Access Compliance Report

Public Rights-of-Way

(Curb Ramps)

Intersection ID: 2750	Main Street: BRADWELL_DR	Cross Street: MANTARIO_DR	Location:	W
ADA ID: EC39EA45C9E2	Ramp Type: PerpDiag	Initial Pass/Fail: Fail	Overall Compliance: No	Severity Score: 22.5
Codes/Mitigation Info/Possible Solution		Field Measurements/Component Compliance

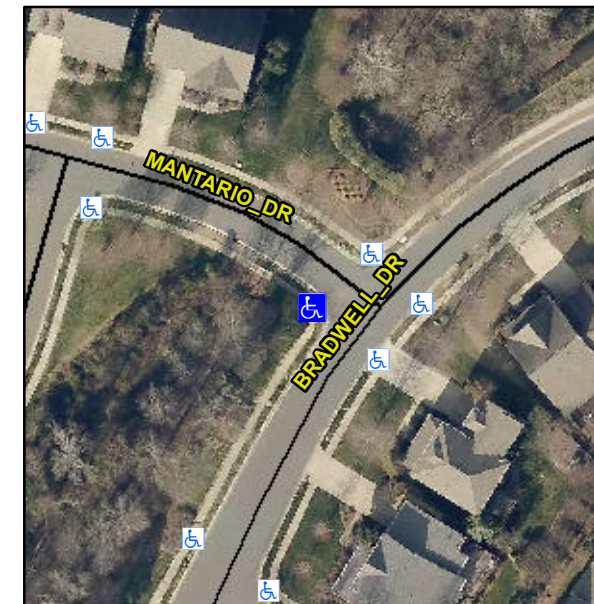
R304.5.1, R304.2.2, R304.5.3

Compliance	Description	Data	Compliance	Description	Data
N/A	Ramp Length (in)	48.0	No	Ramp Slope (%)	10.4
No	Ramp Width (in)	41.0	No	Ramp XSlope (%)	2.1
N/A	Flare Type LT	N/A	N/A	Flare Type RT	N/A
N/A	Flare Slope LT (%)	N/A	N/A	Flare Slope RT (%)	N/A
N/A	Flare Traversable LT?	N/A	N/A	Flare Traversable RT?	N/A
N/A	Landing Length (in)	N/A	N/A	DWS Provided?	N/A
N/A	Landing Width (in)	N/A	N/A	DWS Contrast?	N/A
N/A	Landing Slope (%)	N/A	N/A	DWS Length (in)	N/A
N/A	Landing X Slope (%)	N/A	N/A	DWS Full Width?	N/A
N/A	Landing Curb? (Y/N)	N/A	N/A	DWS Offset (in)	N/A
N/A	Shared Landing?	N/A			
N/A	Gutter Ponding?	N/A	N/A	Gutter Slope (%)	N/A
N/A	Gutter Lip Ht (in)	N/A	N/A	Gutter X Slope (%)	N/A
N/A	Painted X Walk1?	No	N/A	Painted X Walk2?	No
	X Walk 1 Direction	To SE		X Walk 2 Direction	To NE
N/A	X Walk 1 Width (in)	N/A	N/A	X Walk 2 Width (in)	N/A
	X Walk 1 Slope (%)	0.1		X Walk 2 Slope (%)	0.7
	X Walk 1 X Slope (%)	1.9		X Walk 2 X Slope (%)	1.7

Remove & Replace Curb Ramp With Two New Directional Ramps or Equivalent.
